Northern Railway

No. 308-W/0/3/Genl./Br./S&D/Part-II

Subject:- Standard type plan (Revised) for General arrangement Drawing for construction of Road Under Bridge (RUB)/Limited Height Subway (LHS) for single & multiple track.

N.R.H.Q.E. PLAN NO. XEN/RC/2118/GAD

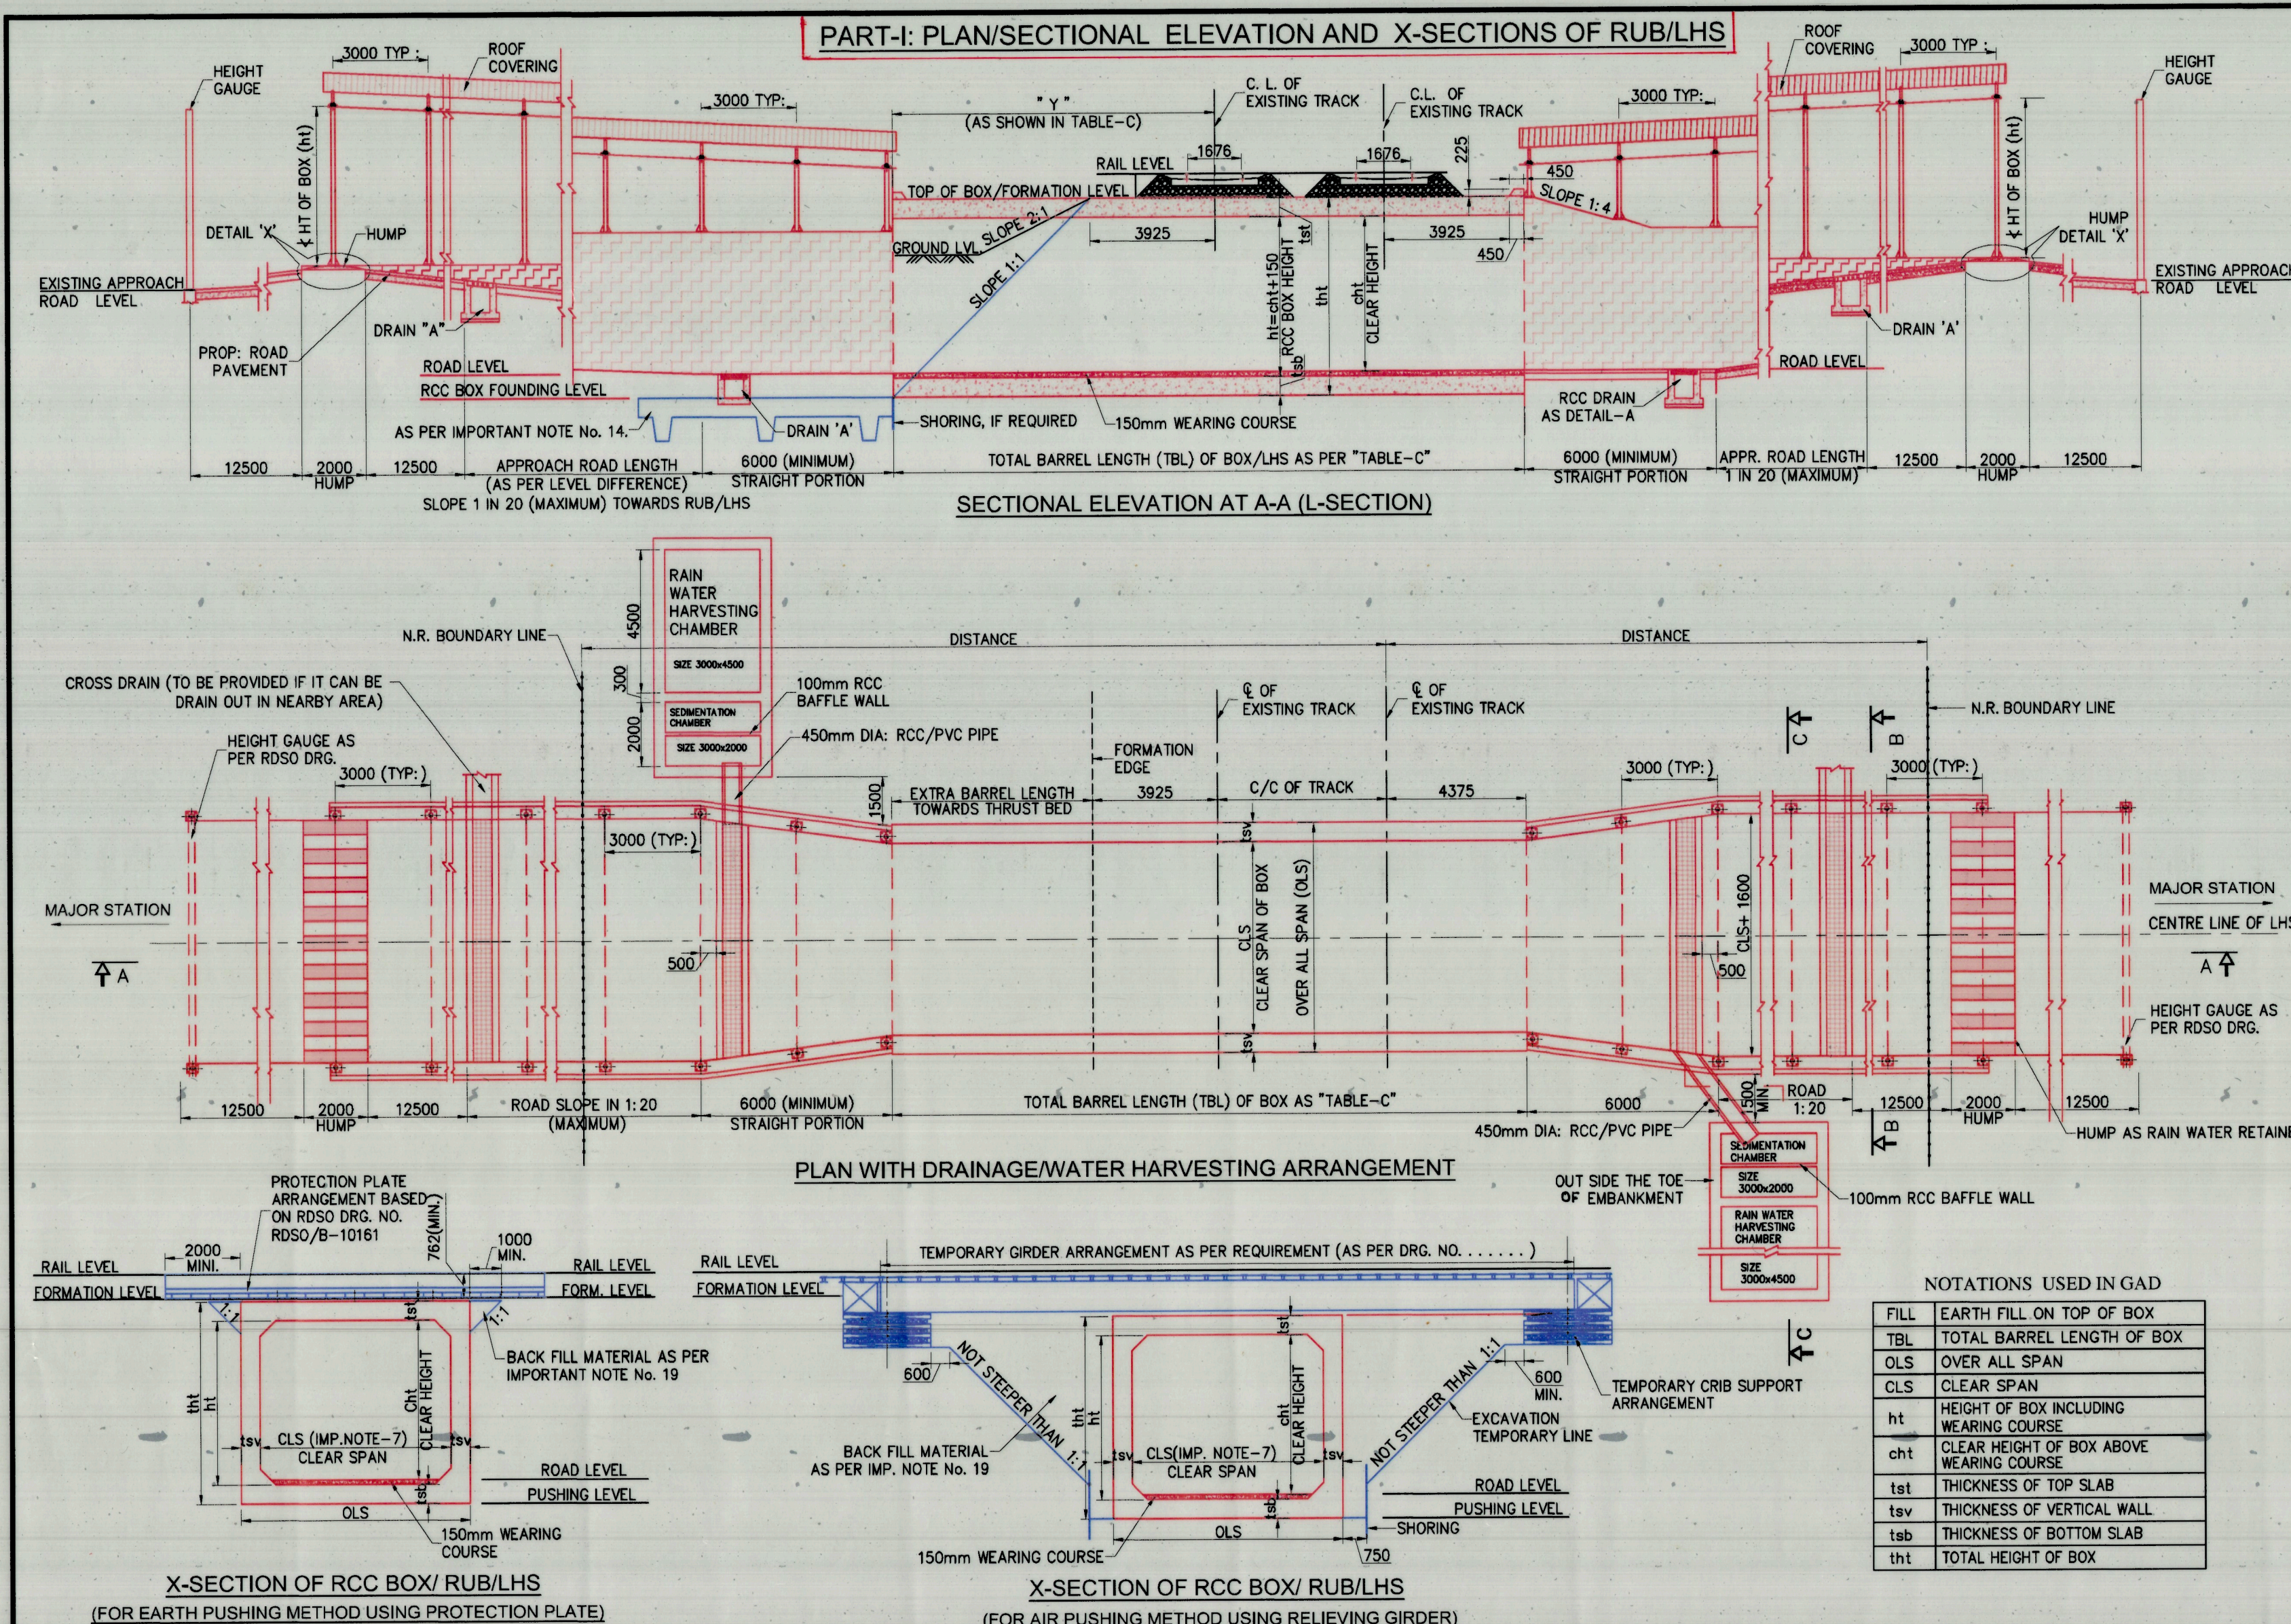
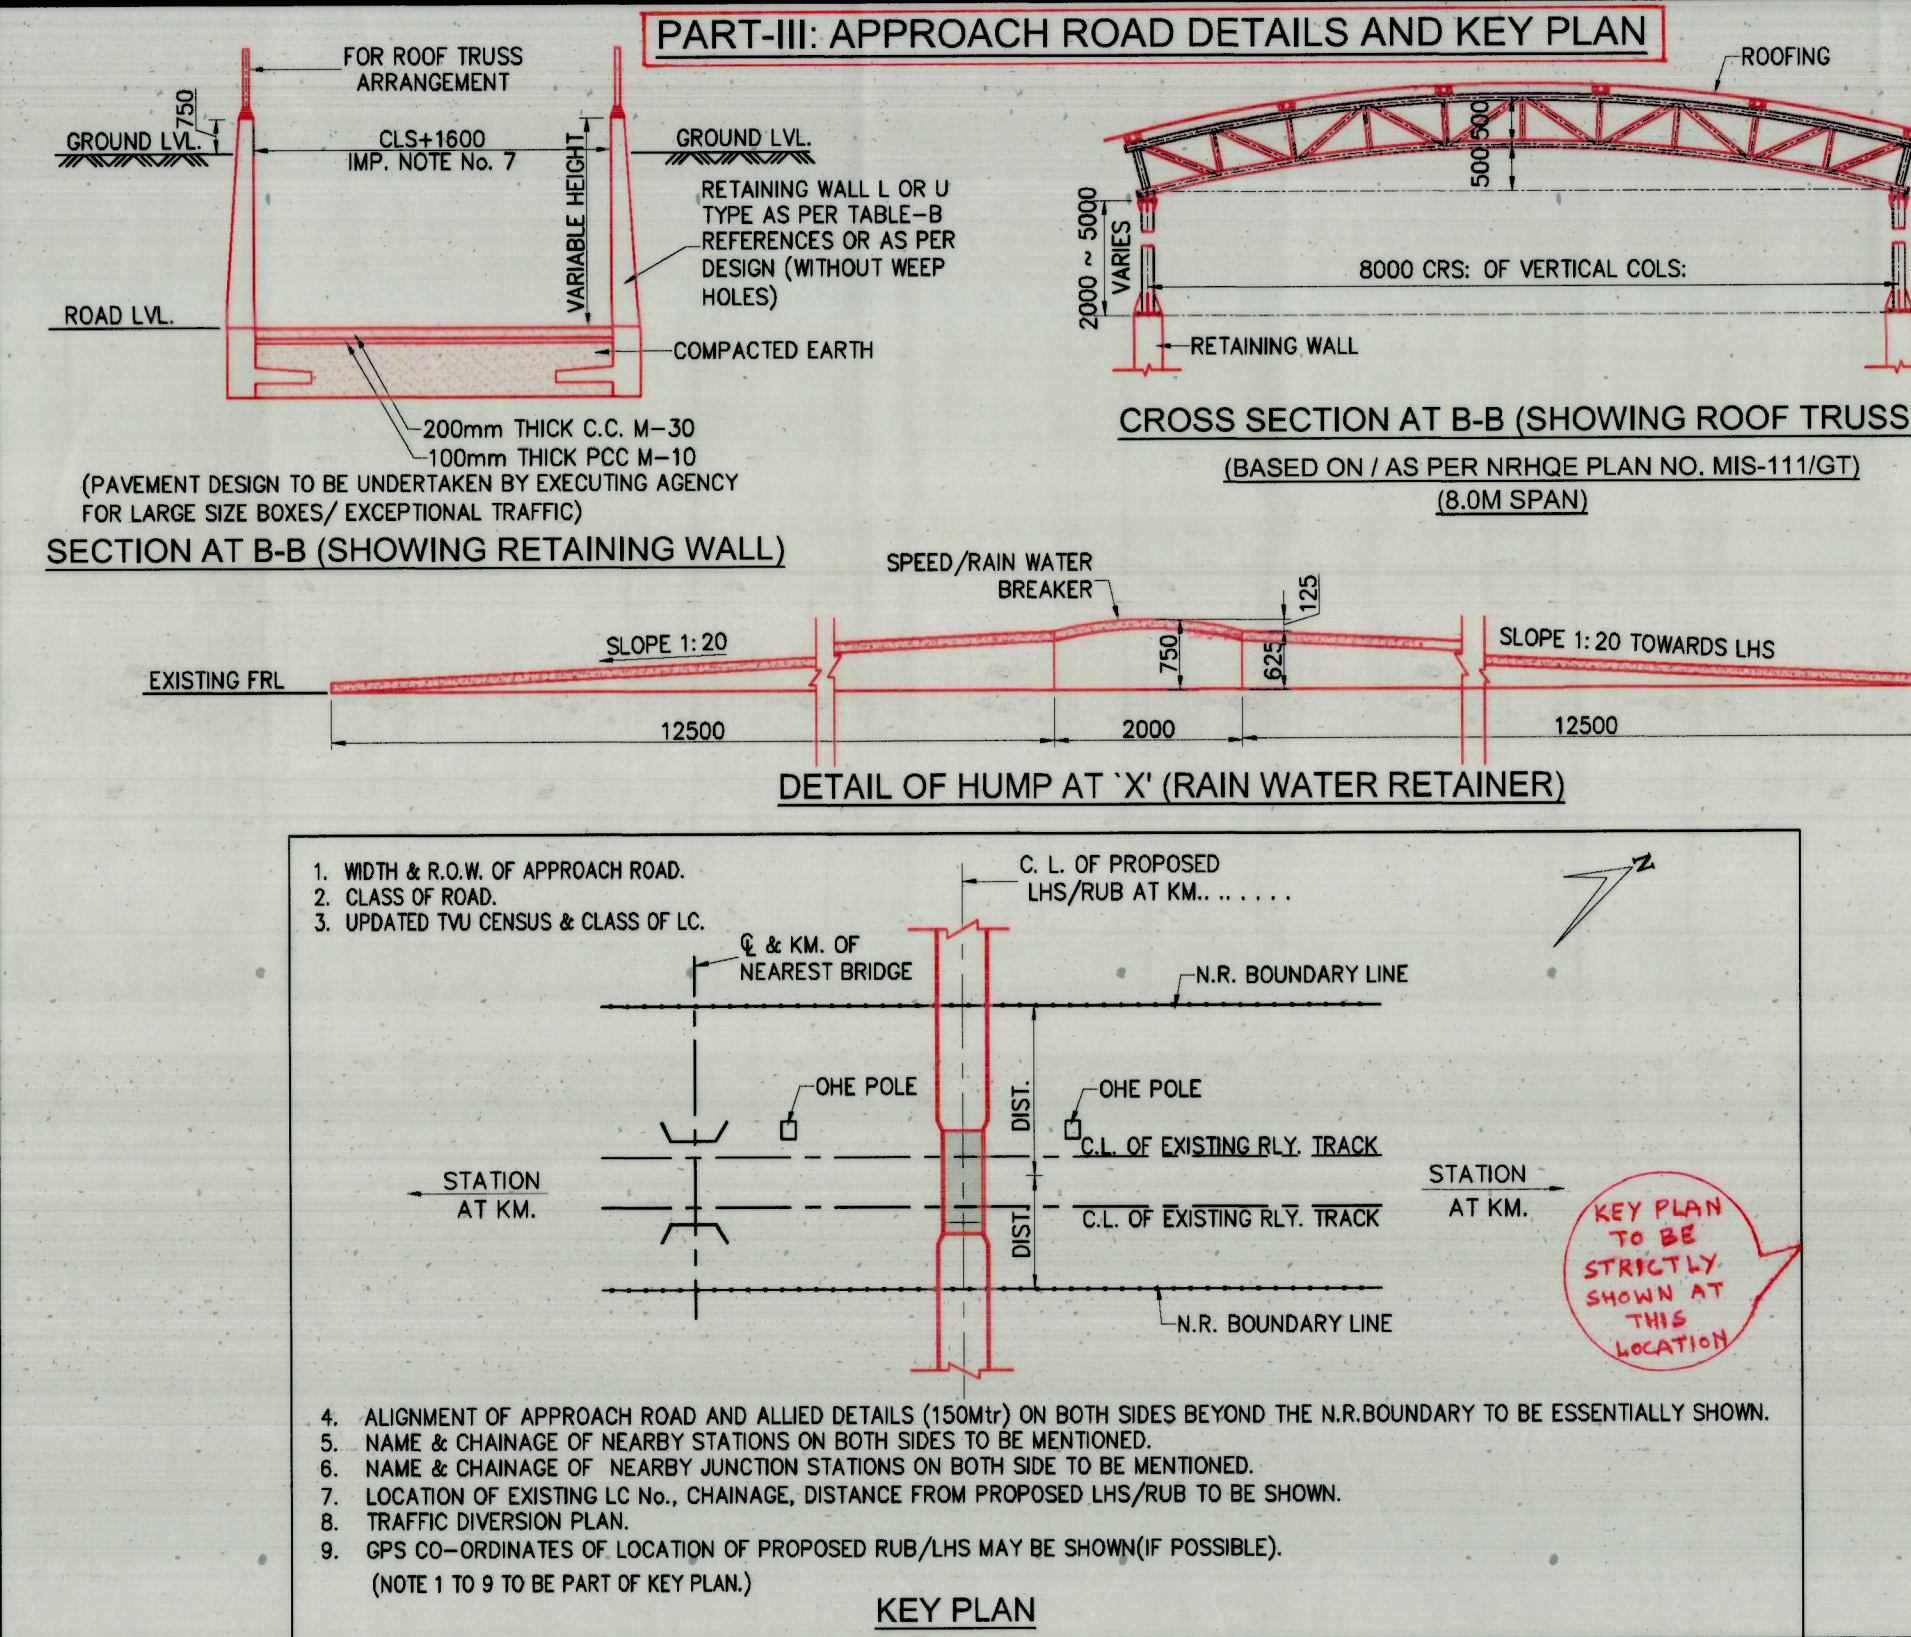
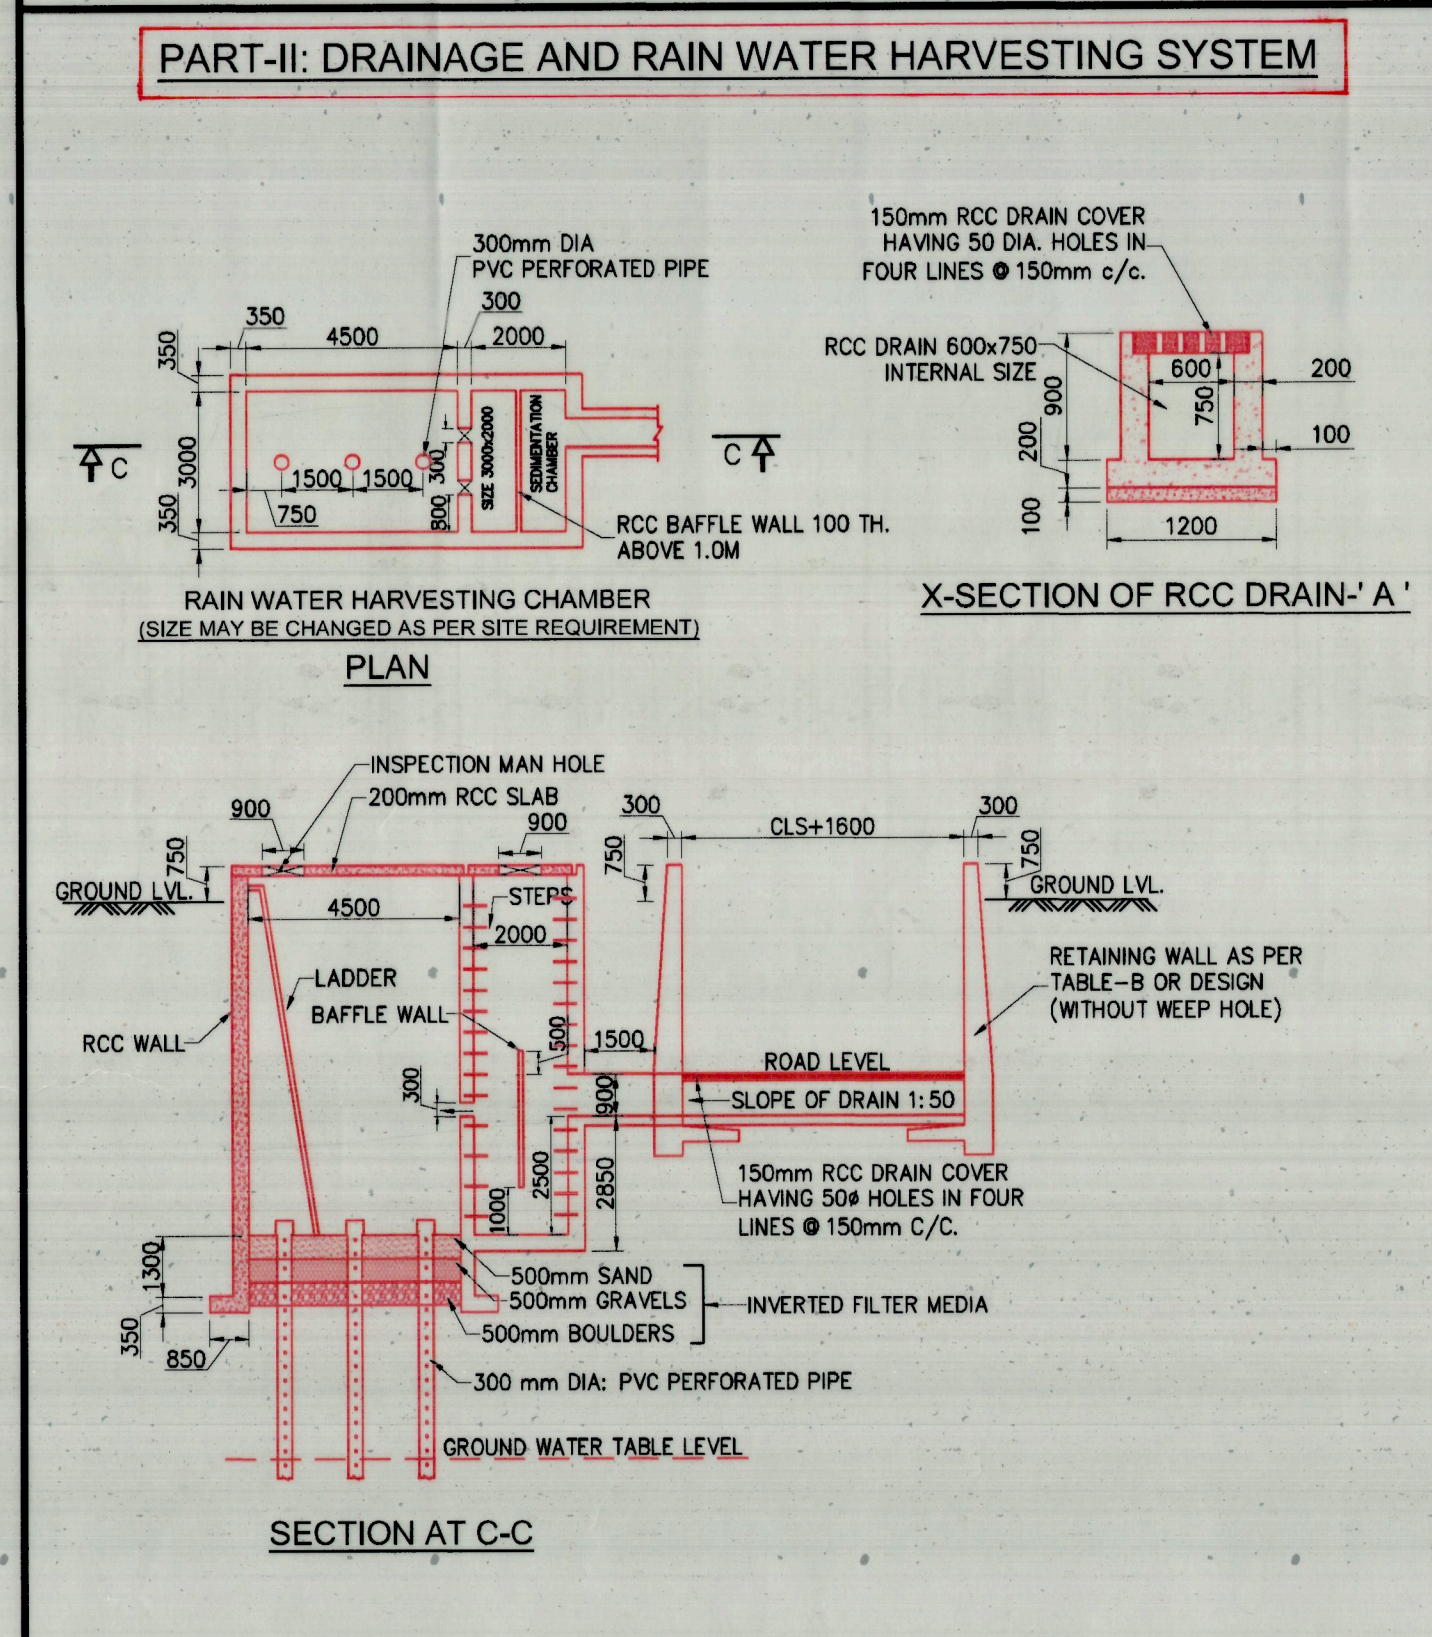
The Type Plan No. XEN/RC/1425/GAD/R2 of Limited Height Subway (LHS) currently in use was issued when segmental boxes were in use for LHS constructions. RUB/LHS work as per the latest guidelines of Railway Board is currently being done mostly by earth/ Air pushing method using plate protection/ Restricted Height (RH) girders. Hence, a revised Type Plan is being issued. It will supersede the NRHQE Plan No. XEN/RC/1425/GAD/R2. The main features of the revised Type Plan for RUB/LHS is as under:-

1. This Type Plan is divided in four parts:-

2. **Part-IV** has **four tables** from Table-A to Table-D.

3. Notes are divided in two parts i.e. Important Notes (**not to be changed**) and Site Specific Notes which can be changed according to the site conditions.

4. Drainage certificate from Divisional SAG Officer included in revised Type Plan, which will be part of GAD.
 5. **8.0m** cover shed drawing No. MIS-111/GT has been incorporated in this type plan.
 6. Already approved **Thrust Bed drawings** can be used as already directed vide CBE Letter dated 02.06.2025.
 7. The ACAD Soft Copy of this type plan is being shared with Divisions/ Construction Unit/ RSP unit for ease of preparation of GAD and to maintain similarity in all proposed GADs of LHS/RUB.
- It is advised to use this type plan for all future proposed works of LHS/RUB with immediate effect.**
